**MONONGAHELA VALLEY ASSOCIATION OF HEALTH CENTERS, INC.
FAIRMONT, WEST VIRGINIA
MVA CLINIC HRSA C8E GRANT RENOVATIONS**

ADDENDUM #2

July 15, 2022

THRASHER PROJECT #060-10257

1 FIRST FLOOR PLAN
A0.01 1/8" = 1'-0"

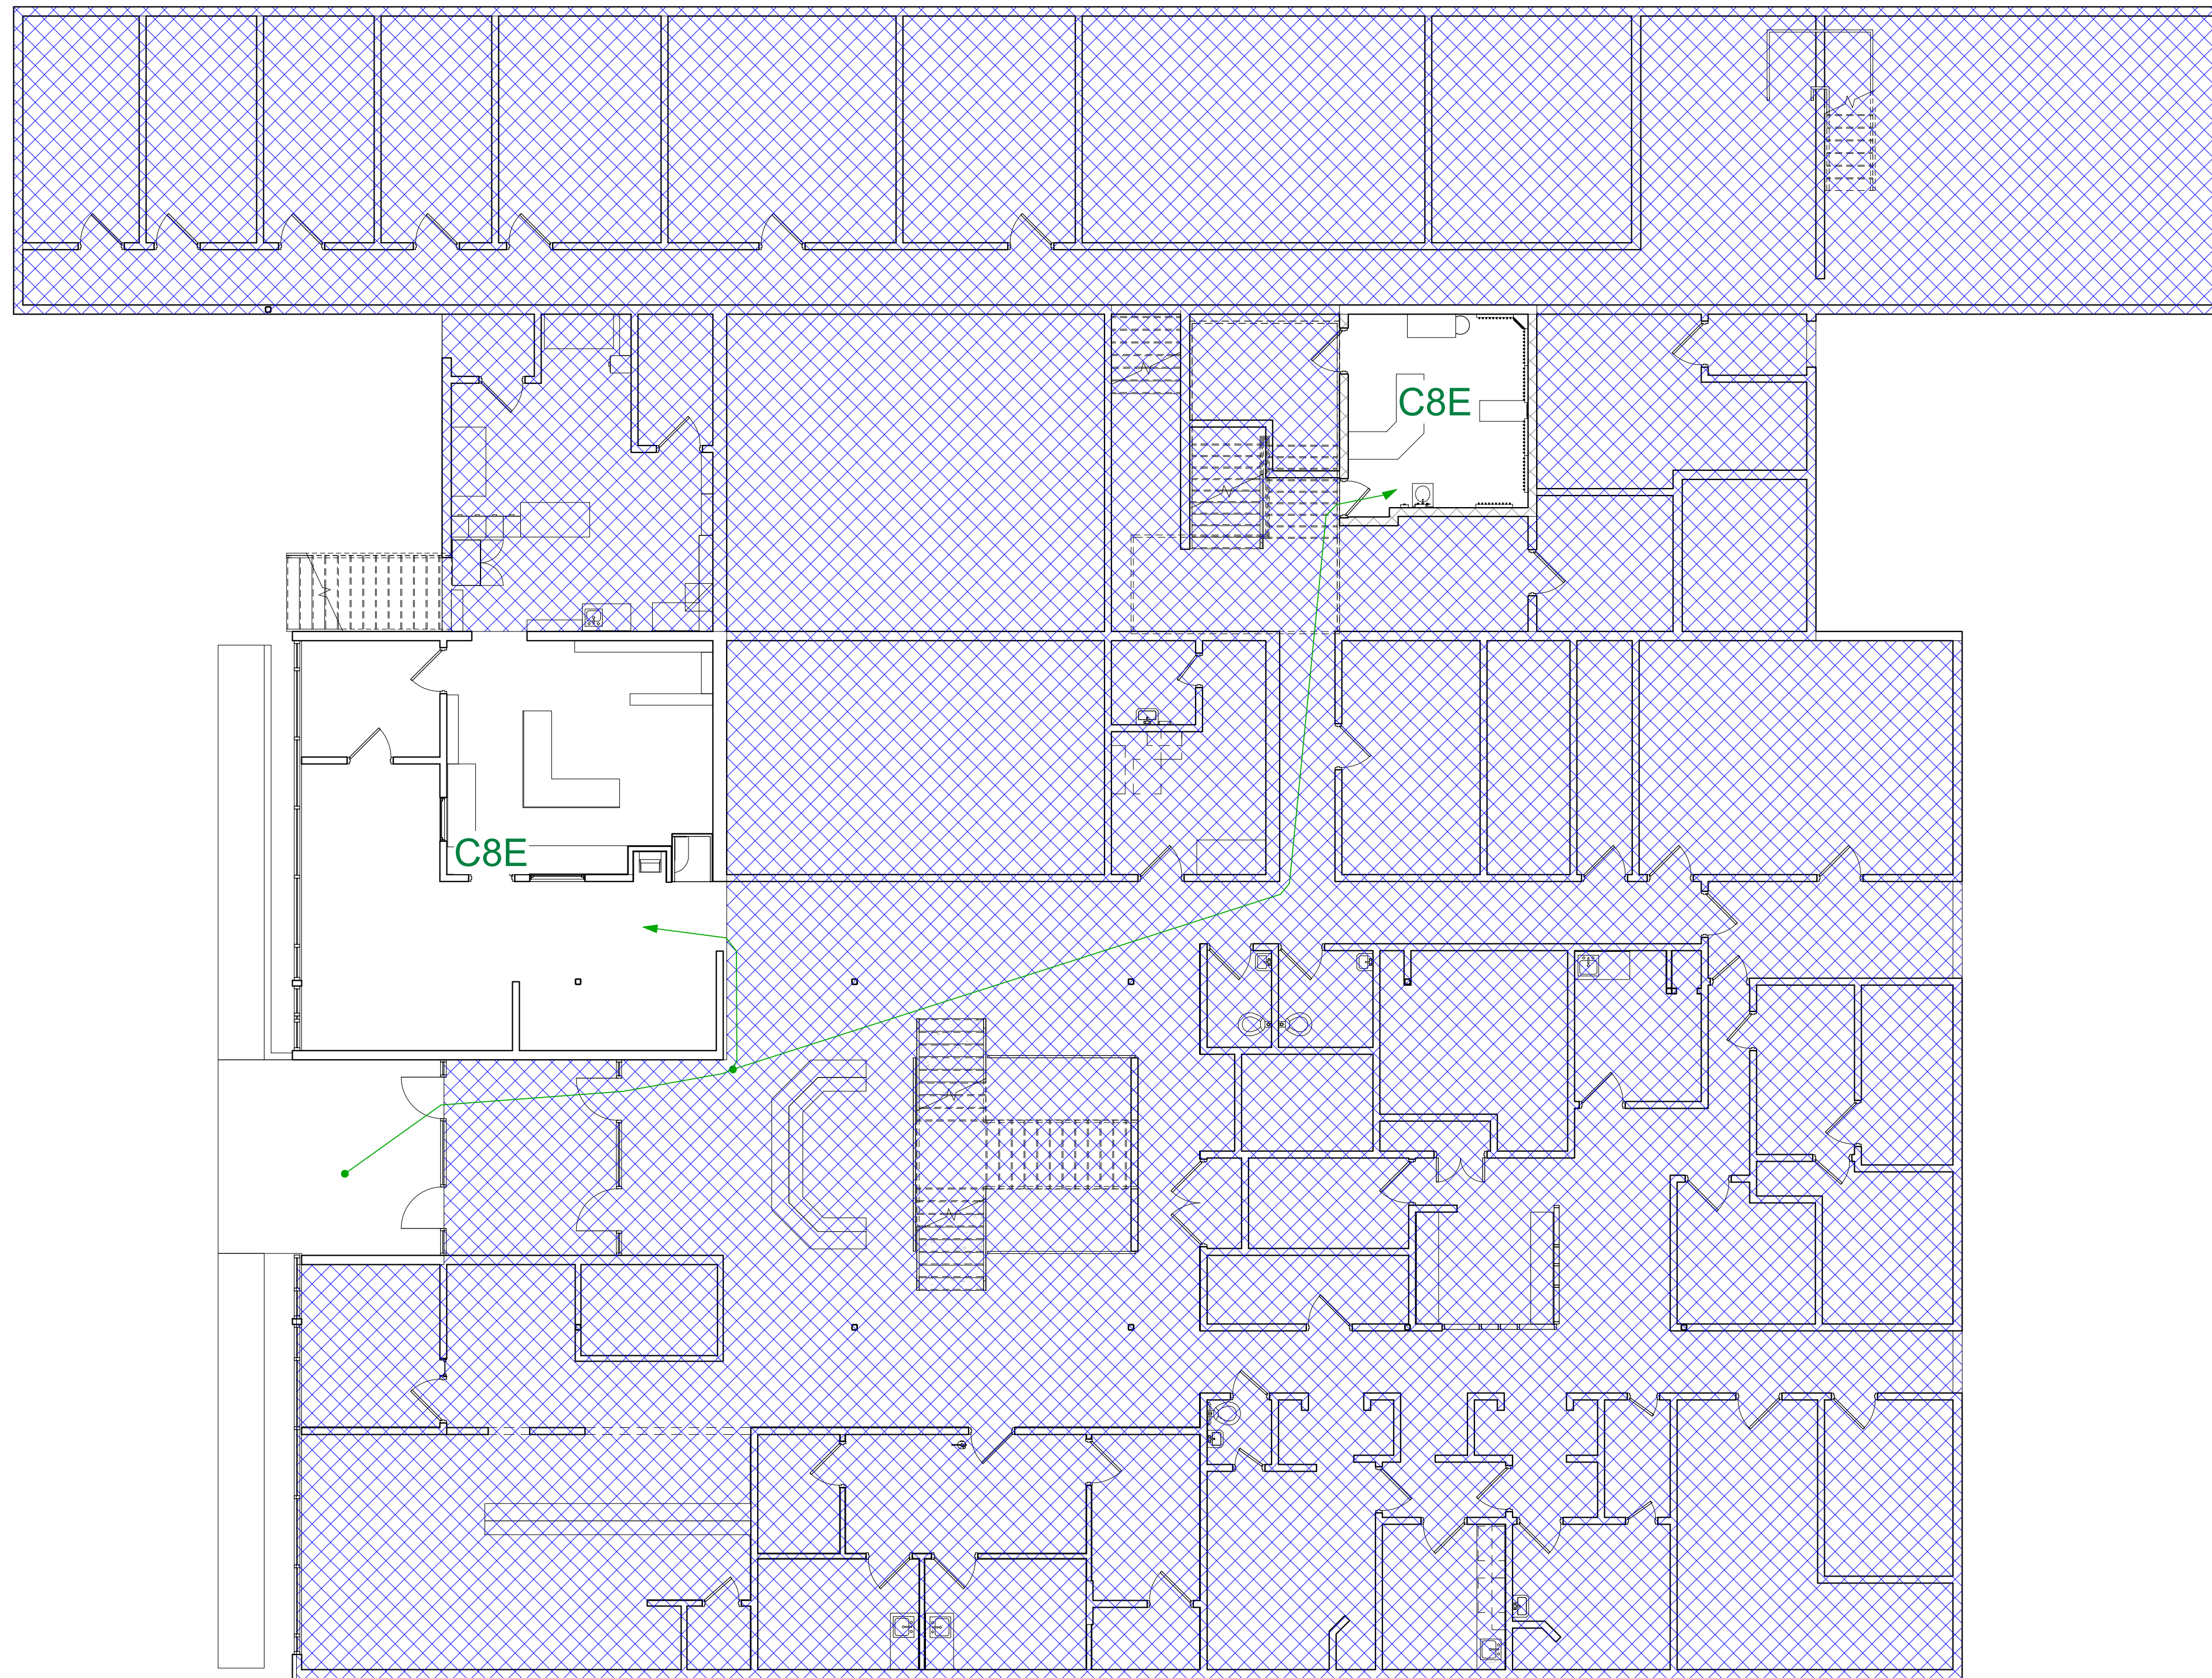
Question 2. Is it possible to get the existing building overall floor plans so we can figure how to access the areas of work for demolition and construction?

Answer 2. Yes, these overall plans are attached to this addendum.
